REPORT TO CALGARY PLANNING COMMISSION

DEVELOPMENT PERMIT	ITEM NO: 02	
	CPC DATE:	2011 November 10
	DP NO:	DP2011-1057

PROPOSAL:
New: Multi-Residential Development (165 units)

SUPPLEMENTARY REPORT

Day view of podium and street frontage landscaping

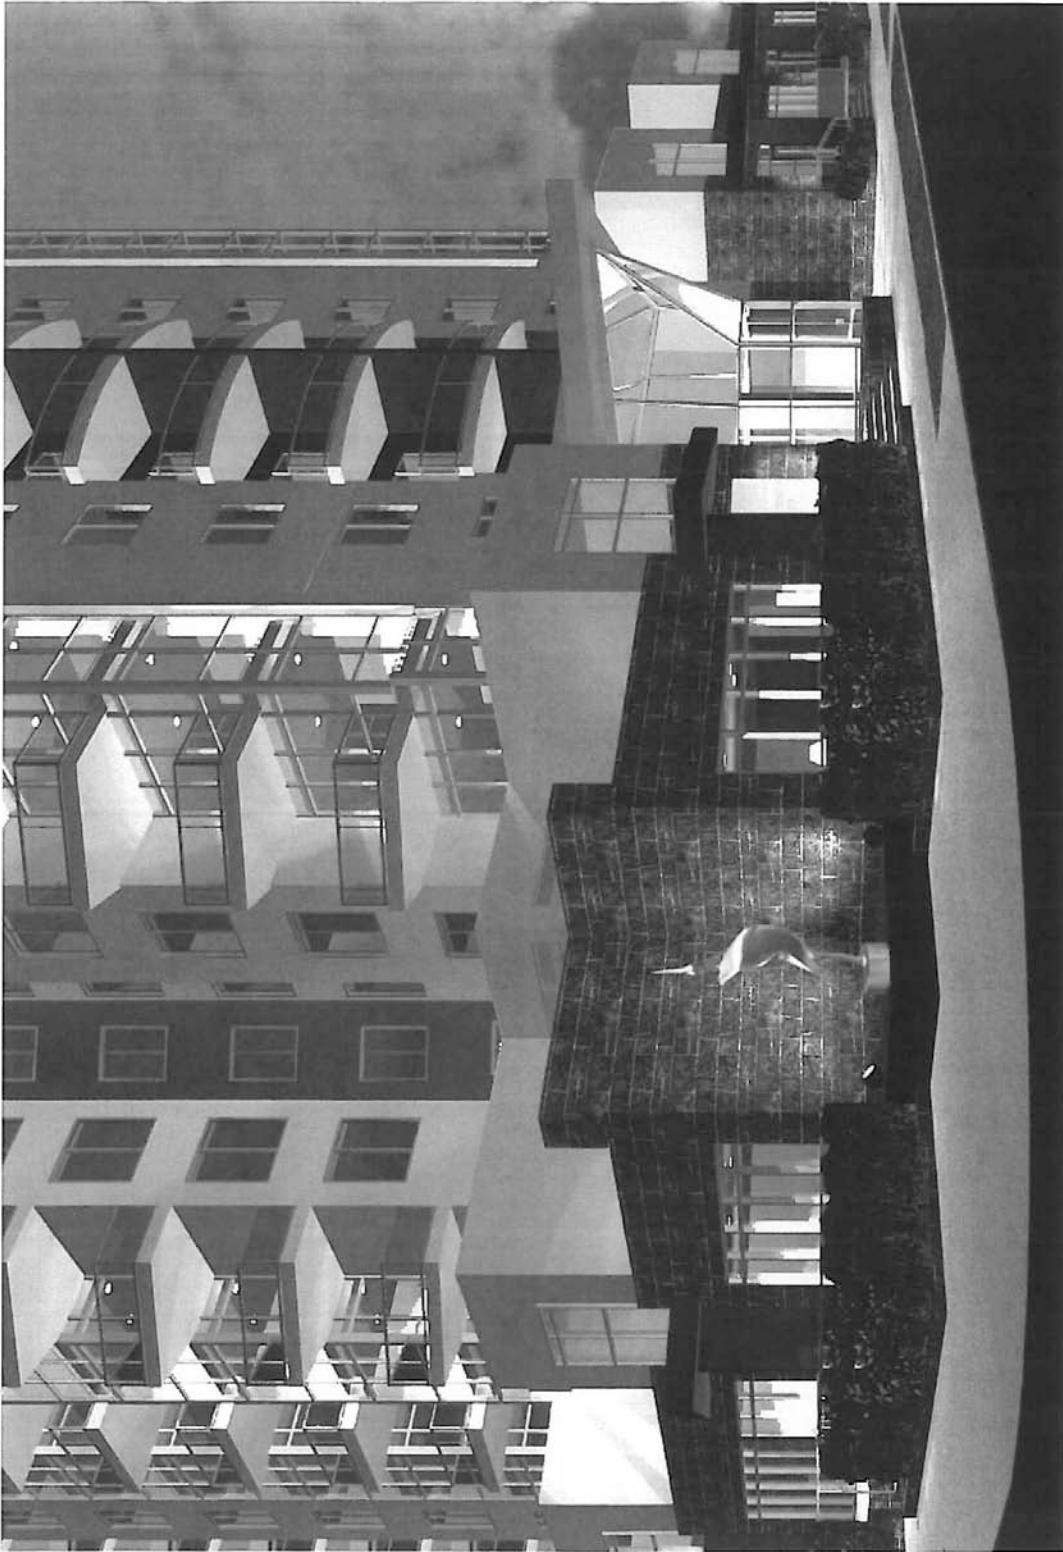
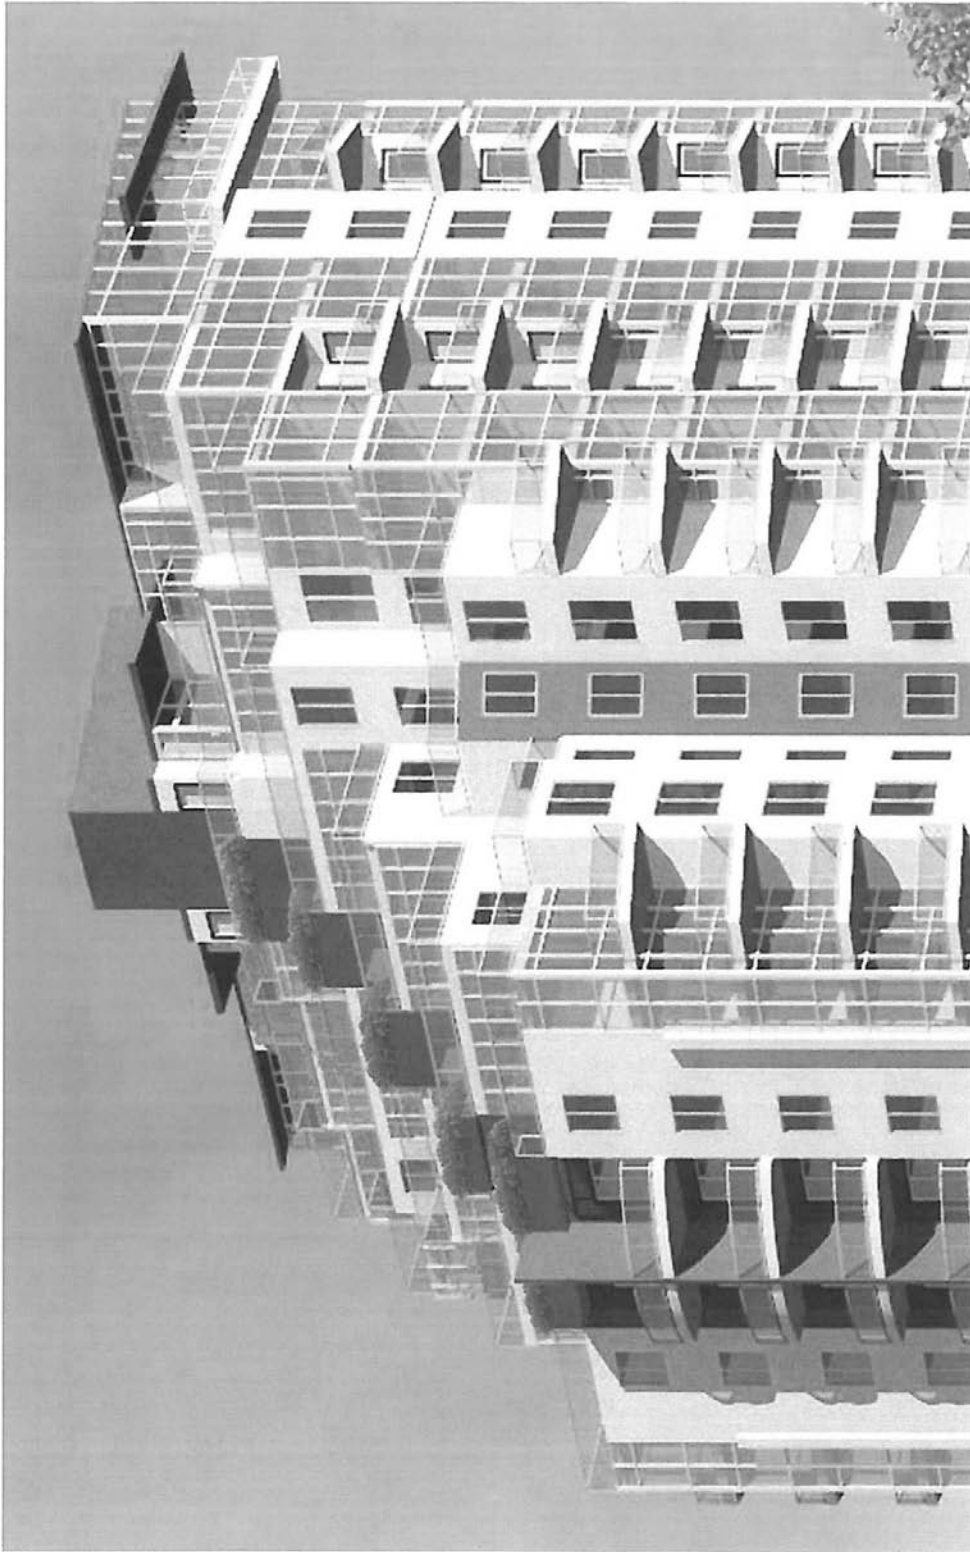
<p>The Panel has a concern that the lack of detail in the package made it impossible to understand whether the design of the town house units interfaces appropriately with the street, particularly with respect to issues of privacy that may be provided through such things as grade separation planting and screening.</p>	<p>A cross section is provided which is part of the construction drawings shows the relationship of the windows to the suite, the patio area, the shrub buffer zone in front and the Greenway. The frosted glass of the patio railings allows for a person to view over the rail to see passers-by, but sets passers-by at a lower level than those sitting in the patio. The deep shrub area in front of each patio ensures that passers-by do so at a distance from the railing increasing privacy and also providing an attractive flowering plant area with little maintenance required to give the patios a feel of quality and park like surrounding. Also attached is a photo of a similar street patio showing a welcoming entry.</p>

3. The attached street view of the building shows the plinth for the artwork and a close-up of the intended artist's capabilities and style of work. The corner has been carefully designed to provide an attractive backdrop to the artwork and the area is designed to provide for a more spacious and interesting corner to the street.

4. The green staircase is governed by the same geometry as the shadows caused by the building and will be easily visible to anyone in Central Park standing on the internal sidewalk or walking around in the green space. The attached large view shows the visibility of a 1m high shrub in each planter.
